Change of socket material and integration of V-Lock cord retaining feature as standard.

Product Change Notification					C20F screw-on front version PCN		
owner	creation date	release date	released by	change order no	rev	page	D10-004-748
sariogar	2016-05-31	2017-07-11	sariogar	2010167	A	1 of 2

Old product appearance	New product appearance
<p>Screw-on mounting from front side</p>  	<p>Screw-on mounting from front side</p>

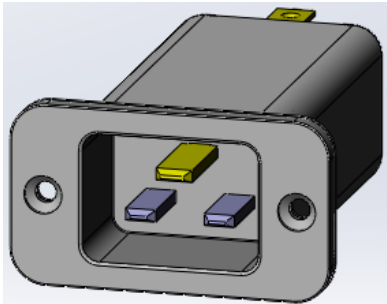
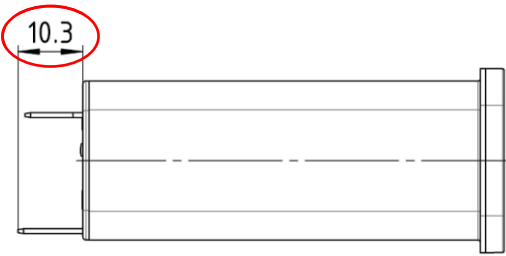
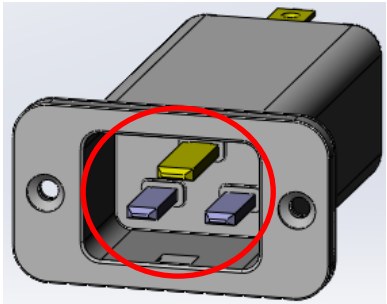
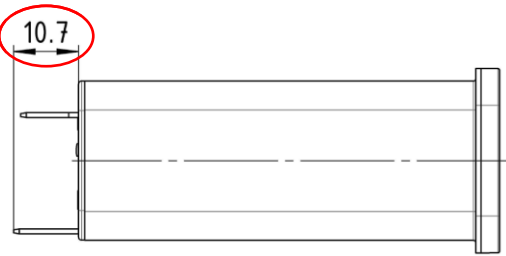
- Socket material change from PA6 to PA66/6 to pass the enhanced requirements of glow wire test acc. to IEC 60695-2-12 and -13
- V-Lock cord retaining integrated as standard feature (not an option anymore)

Form	Yes	Socket has notch for V-Lock cord retaining, new form on extended socket dimension and socket base.
Fit	Yes	Installation depth is 0.4 mm extended.
Function	Yes	V-Lock feature is standard (not an option anymore)
Production Site	No	There is no change of the production site
Product Label	No	No label change
Customer Action	Yes	PE-Terminal is 0.4mm longer. Check installation depth in the application. Change SCHURTER part number if affected.

As the V-Lock notch and material for enhanced glow wire tests will be standard features, the material numbers with index .21 are obsolete and will be replaced by the standard numbers:

C20F.0001.21	⇒	C20F.0001	C20F.0101.21	⇒	C20F.0101
C20F.0002.21	⇒	C20F.0002	C20F.0102.21	⇒	C20F.0102
